PAUL
STORAGE
BUILD

1724 13TH AVE CT NW
PUYALLUP, WA 98371

PRRRSF20241395

SITE PLANS &
FRAMING DETAILS

Project Number	-
Date	9/3/2024
Drawn By	CS
Checked By	GM
	A001
Scale	Varies

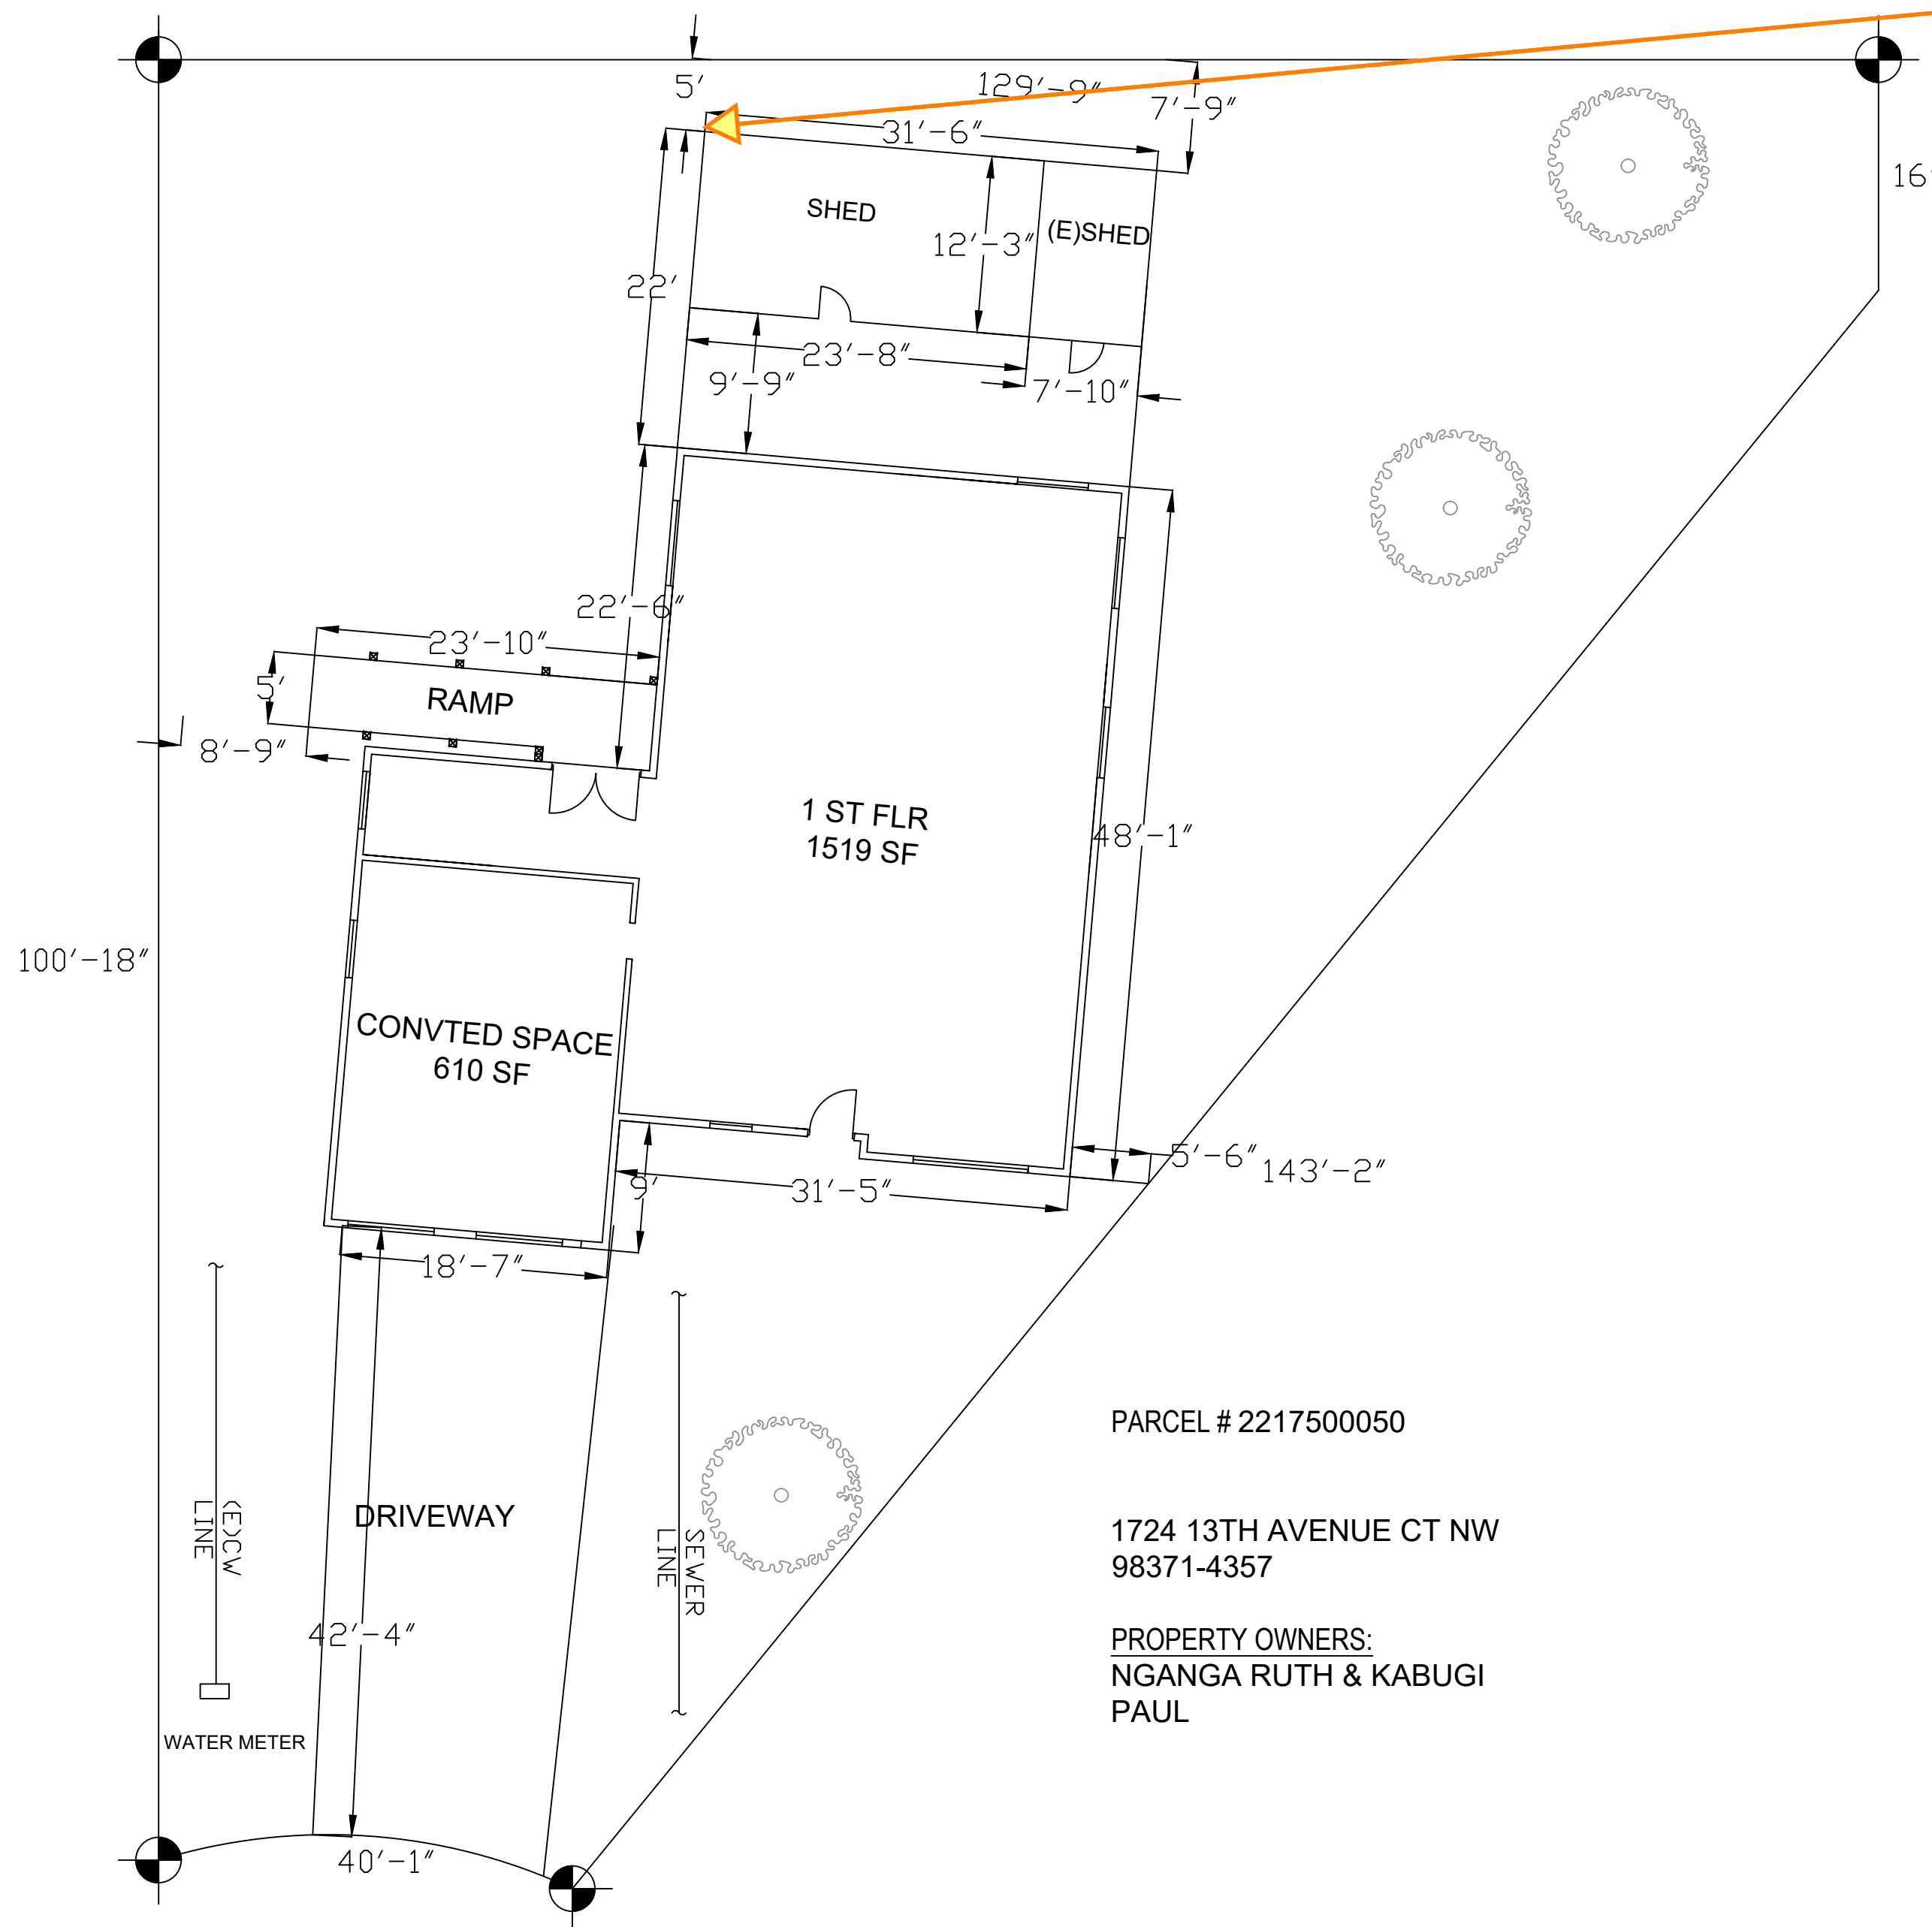
Any walls less than 5 feet shall be a 1 hour fire rated wall. Any projections to include overhangs and eaves that are 5 feet to 2 feet shall be 1 hour fire rated on the underside. Projections under 2 feet are not allowed per code. Contractor to string property lines to verify with inspector the distance of walls and all projections.

Before proceeding with work, it is recommended to verify the distances to the property line with the inspector to ensure that the fire prevention measures mentioned above are not required.
